GeoSolve Ref: 240480.03

3 December 2025

Geotechnical Engineering Assessment Memo Bendigo-Ophir Gold Project Fast-Track Application Assessment

Figure 2: Unstable zone around abandoned mines (https://www.worksafe.wa.gov.au/system/files/documents/2025-02/MSH_G_SafetyBundWallsAroundAbandonedMines.pdf)

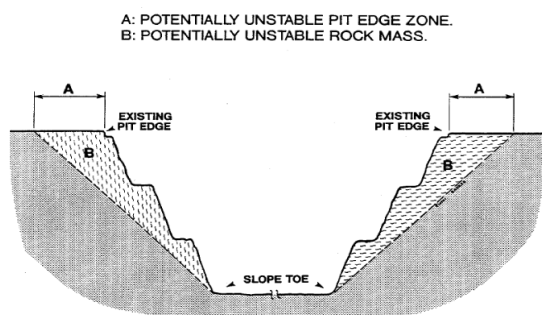
We understand that backfilling is not proposed for the RAS and SRX pits; these are instead to remain as open pits with associated pit lakes in perpetuity. There will therefore remain an unstable zone around these pit margins on closure and bunding is proposed to prohibit public access. The extract below from Western Australia guidance illustrates this concept.

1. Designate an exclusion zone around the pit to prevent public access. The extent of the exclusion zone shall be determined based on residual stability risks and safety considerations and must be approved by the Consent Authority.
2. Construct and maintain physical barriers (e.g. bunds) and install appropriate signage to restrict entry and warn of hazards.

Figure 3: Stability Analysis Extract from B.28 Report (p46 & p47), Plan extract from C.02

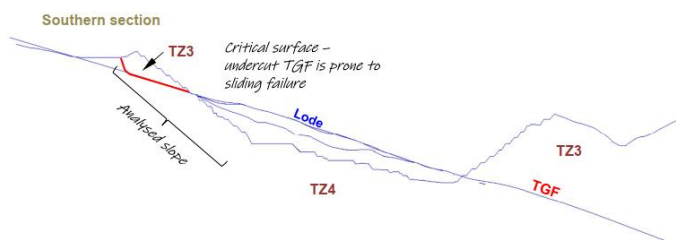
However, it is important that any land outside the mine site is not destabilised by the mining operations as public access may be possible in these areas (i.e. the land bordering the southwest of the CIT pit and the RAS pit is public conservation land). Typically, a long-term factor of safety (FoS) of at least 1.5 under static loading conditions would be required within land accessible to the public and it appears from the stability analysis of the RAS pit when at full depth that this may not be achieved.

Based on the basic section and the analysis results there is a risk that these typical target factors of safety are not achieved in public land, and as noted this analysis is preliminary. The section above would also suggest there is the potential for sliding along the TGF to extend beyond the site boundary, although likely not onto Department of Conservation (DoC) land.

The other issue is that as the RAS pit will not be backfilled, an exclusion zone around the pit will need to be established on abandonment as noted above to permanently restrict the public from approaching the pit edge. Typically, this involves the construction of a rock bund (generally 2 m high by 5 m wide) and this exclusion zone could encroach on DoC land, although buttressing of the pits walls could mitigate this issue on closure.

The consent holder must ensure that the stability of ground outside the project site boundary is not adversely affected by the construction or operation of any of the deep mining pits.

1. A minimum FoS of 1.5 shall be maintained under static loading for all ground outside the site boundary, unless an alternative FoS is agreed in writing by the Consent Authority.
2. Prior to excavation, the consent holder shall provide a geotechnical stability assessment prepared by a suitably qualified and experienced practitioner. The assessment must:
 - Model potential failure surfaces and assess FoS for areas outside the site boundary.
 - Identify any mitigation measures or monitoring required to maintain compliance.
3. All stability assessments and monitoring reports shall be prepared by a suitably qualified chartered geotechnical or mining engineer.

Figure 4: Cross Section Through TSF on Closure

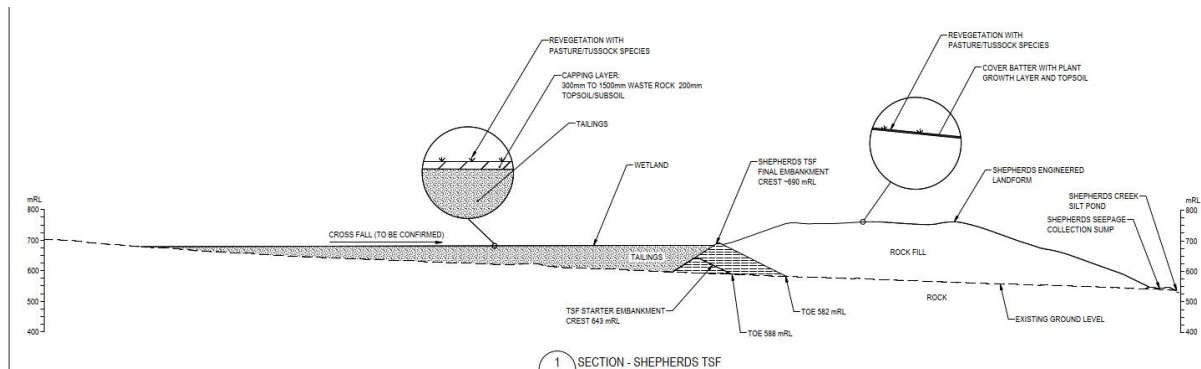
One key point is that the dam will be buttressed by one of the engineering landforms as shown on the section below. We understand this buttress will be constructed from waste rock from the mine pit and will be constructed concurrently with the dam. The designer has not accounted for the additional stability provided by the waste rock buttress in their design which is conservative.

The buttress will result in a significant improvement in the dam stability, which in our view means that post-closure there is no credible risk of dam failure.

Figure 5 – Landslides that Coincide with the RAS Pit

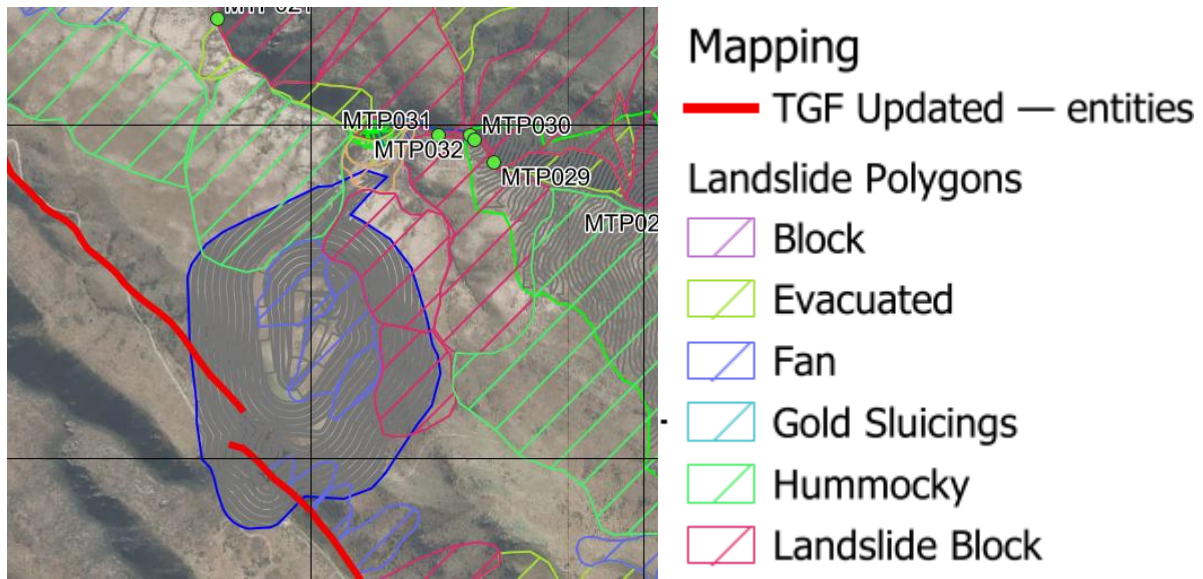
As can be seen in Figure 5, there are two mapped landslides that coincide with the RAS pit. These mapped slides were not immediately apparent on site due to the viewing angle, but given the topography are likely to be trending in a northerly direction. It appears that a significant portion of these landslides will be excavated out as part of the mining and therefore the presence of the slides is something that will need to be considered during the initial excavation works by the applicant. As the slides are entirely within the mining site, there will be no external effects.

Figure 6: Extract from B.28 showing portal cross section

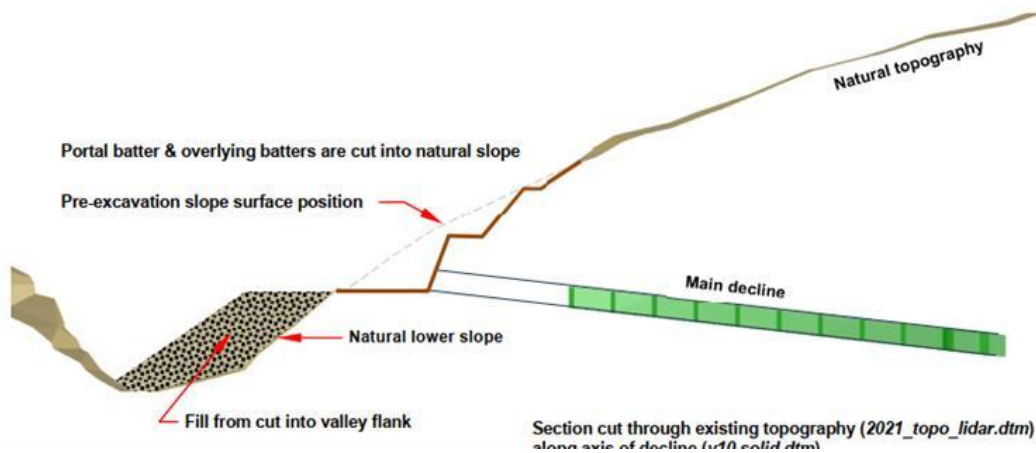
The portal for the underground mining will be constructed at the toe of an ancient schist landslide. The excavation of the portal has the potential to reduce the stability of the landslide, although this may be offset by placement of the spoil within the valley, hence the overall impact may be neutral. As part of the detailed design of the portal this issue should be considered.

The applicant will need to consider these landslides as part of their detailed design of the various elements affected.
